Benefit of Adding DFE to TDECQ

(Comments 381, 382, 383, 384)

**IEEE 802.3dj Plenary Meeting
Madrid Spain**

Figure 180-4—Receiver sensitivity (OMA_{outer}), each lane (max)

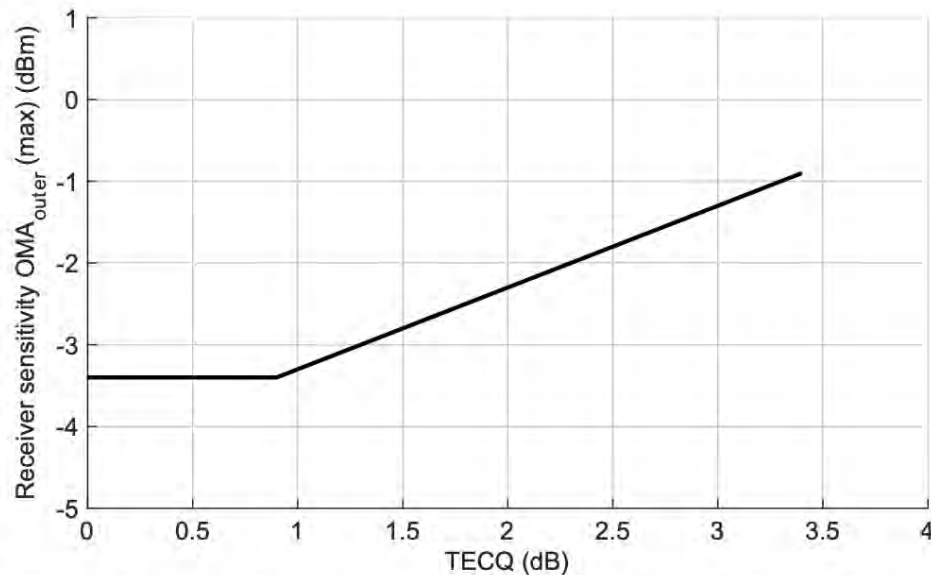
- ❑ Assumed receiver sensitivity as shown in Figure 180-4 show 1:1 relationship between TDECQ and receive sensitivity but actual data from [he 3dj 01 2505](#) 1:0.4 relationship
 - The reason for shallow slope is that the HW receiver is that hardware receiver is more capable compared to TDECQ equalizer
 - Adding 1T DFE to the TDECQ equalizer will improve TECQ penalty with receive sensitivity penalty.

□ TDECQ reduction with 1T DFE for TX with low TECQ

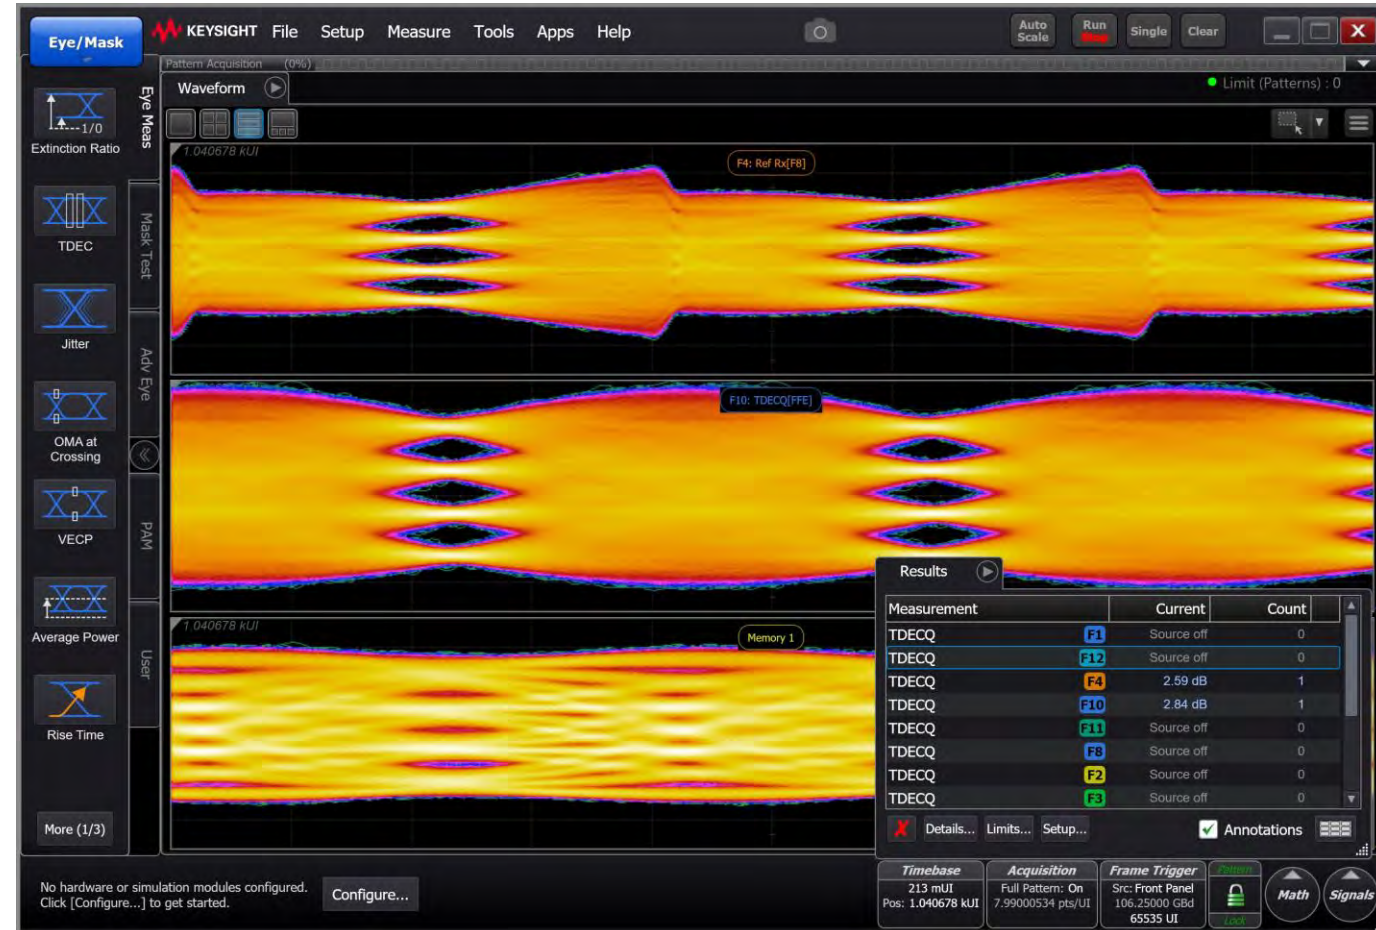
- TDECQ with 15T FFE is 2.84 dB
 - FFE Taps -0.017081, 0.078124, -0.275357, **1.490161**, -0.321593, 0.124306, -0.092210, 0.044500, -0.074899, 0.056275, -0.028502, 0.021386, -0.014024, 0.012652, -0.003738
- TDECQ with 15T FFE + 1T DFE is 2.59 dB
 - FFE Tap -0.008442, 0.045556, -0.166764, **0.995970**, 0.181786, -0.000968, -0.031856, 0.005959, -0.042369, 0.019865, -0.005469, 0.007087, -0.004892, 0.005041, -0.000504
 - DFE Tap 0.283636.

□ TDECQ reduction with 1T DFE for TX with high TECQ

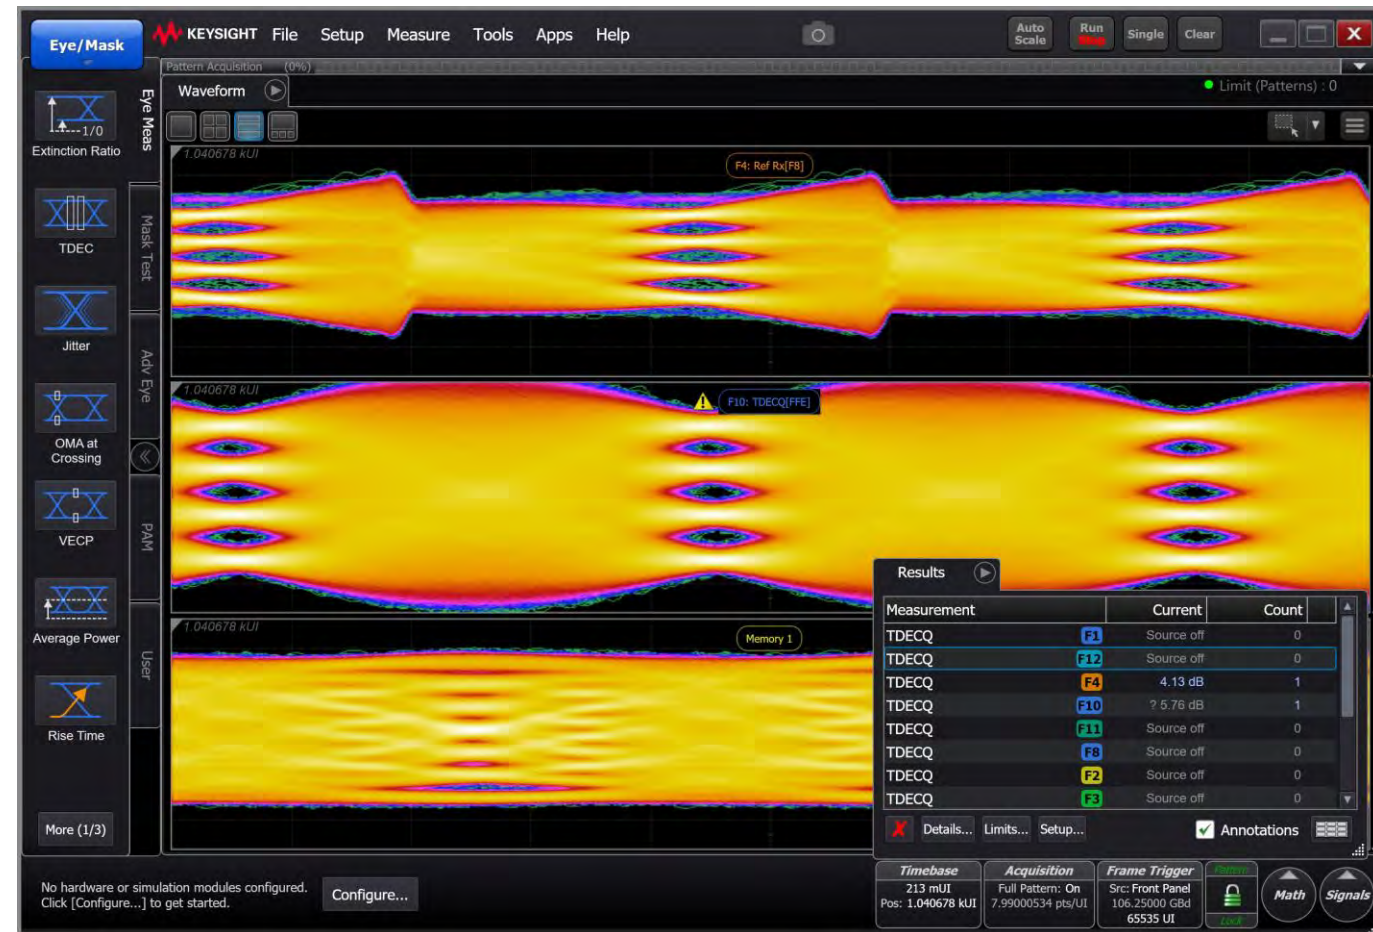
- TDECQ with 15T FFE is **5.76 dB**
 - FFE Taps -0.060232, 0.182759, -0.506969, **1.818684**, -0.532089, 0.157879, -0.044774, 0.005974, -0.044100, 0.035797, -0.010159, 0.003285, 0.018303, 0.004811, -0.029168
- TDECQ with 15T FFE + 1T DFE is **4.13 dB**
 - FFE taps -0.017394, 0.073976, -0.226514, **0.979468**, 0.253183, -0.073706, 0.026715, -0.012512, -0.023035, 0.008908, 0.006088, -0.000323, 0.013989, 0.010717, -0.019560
 - DFE Tap 0.343287

Benefit of Adding DFE to TDECQ

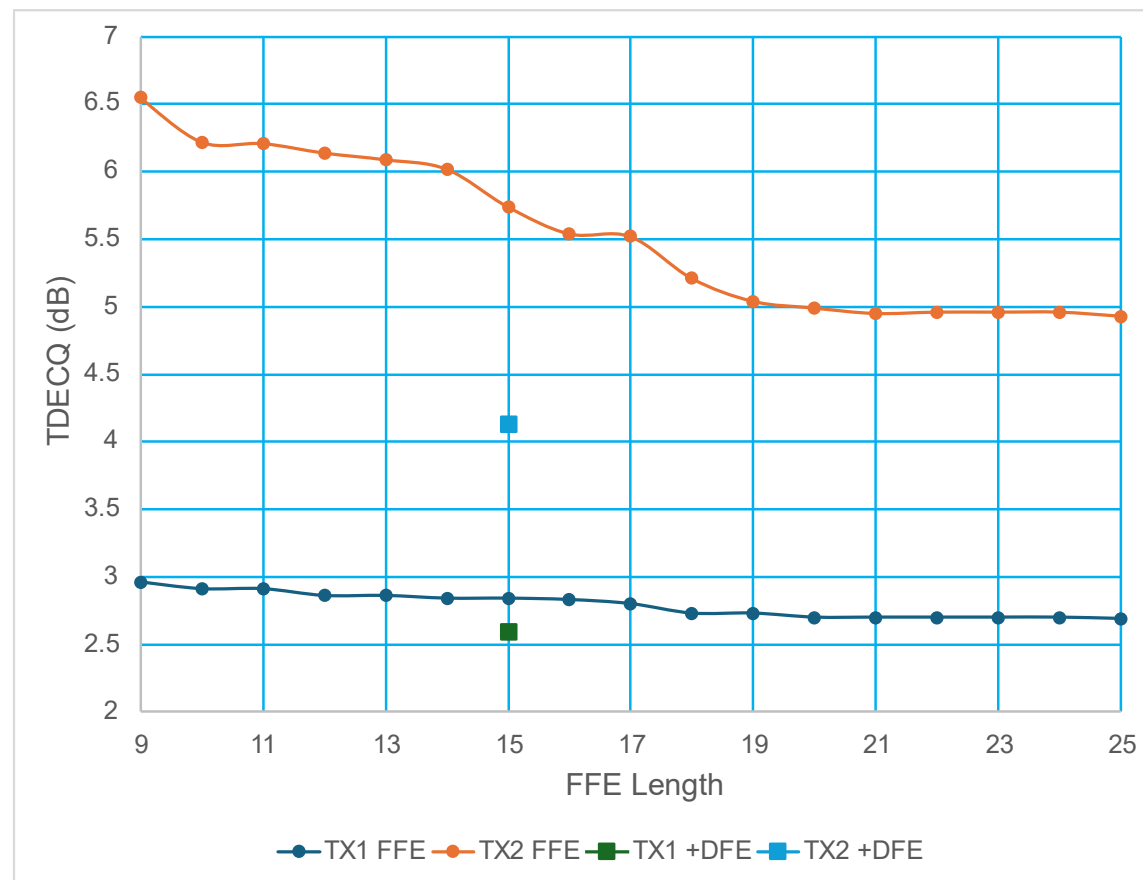
- ❑ Adding 1T DFE to current 15T FFE TDECQ offer more gain than even a 25T FFE
- ❑ Adding 1T DFE also improves TDECQ to Receiver sensitivity penalty
 - Receive OMA sensitivity $2.4E-4$ PreFEC are:
 - TX1 OMA Sensitivity -6.1 dB
 - TX2 OMA Sensitivity -4.6 dB
 - Delta sensitivity = **1.5 dB**
 - Delta TDECQ with 15T FFE = 2.92 dB
 - Delta TDECQ with 15T FFE + 1T DFE = **1.54 dB**
- ❑ TDECQ with 15T FFE + 1T DFE the transmitter penalty matches receive sensitivity penalty 1:1!
